Re: Turkey Point Unit 3
Docket No. 50-250
Order (EA-03-009) Relaxation Request
Examination Coverage of Reactor Pressure Vessel Head
Penetration Nozzles – Supplemental Data

**TURKEY POINT UNIT 3 RELAXATION REQUEST
FROM US NRC Order EA-03-009**

**“Hardship or Unusual Difficulty without Compensating Increase in
Level of Quality or Safety”**

RESPONSE TO REQUEST FOR ADDITIONAL INFORMATION

Figure 10 (Note : Results are for a typical plant, not Turkey Point specific)

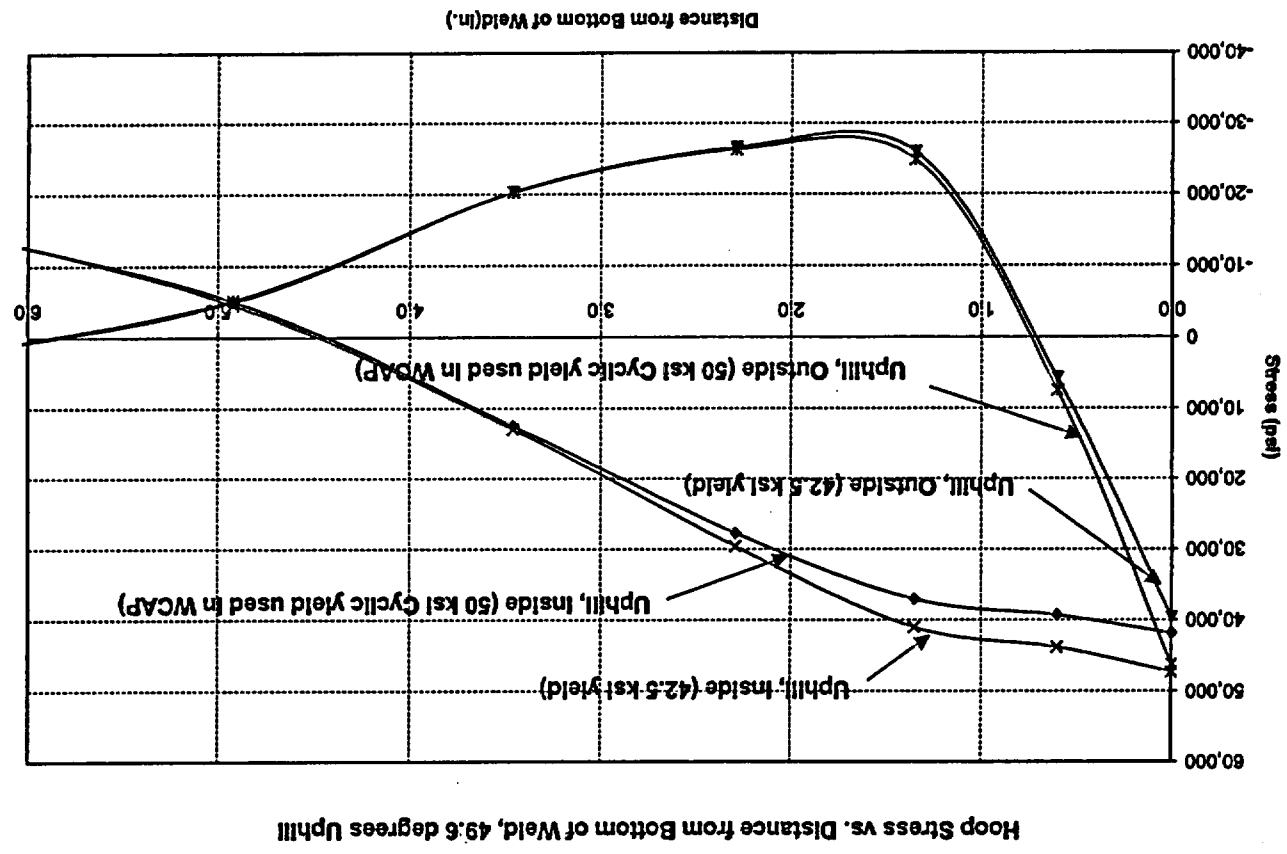
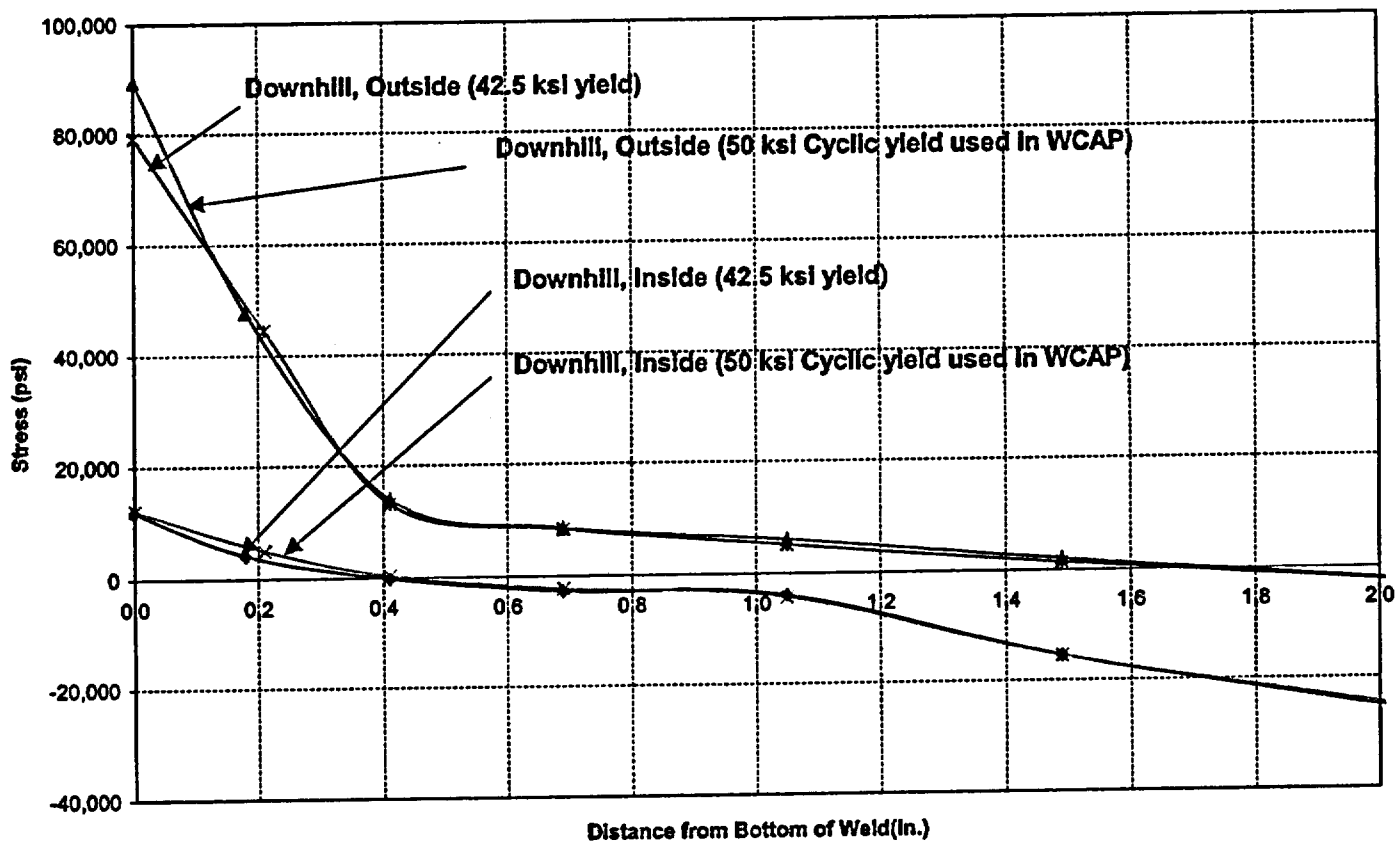
Question 1. In Figures 5-3 through 5-9 of WCAP-16027-P, what is the maximum hoop stress in the nozzle base material greater than one inch from the bottom of the weld? What material properties (i.e., yield strength) were used in these calculations?

Calculations have been performed to compare the results obtained for a lower stress strain curve, corresponding to a monotonic yield strength of 42.5 ksi, on the exact same geometry. The results of the comparison for one of the outermost penetrations is shown in Figures 10 and 11.

The trend in stresses, decreasing with distance below the weld, is the same regardless of the yield strength used. In three of the four cases, the actual stress values are higher for the cyclic stress-strain curve.

Note that the plant depicted in Figures 10 and 11 for this example is not Turkey Point, but the results are typical regardless of the geometry.
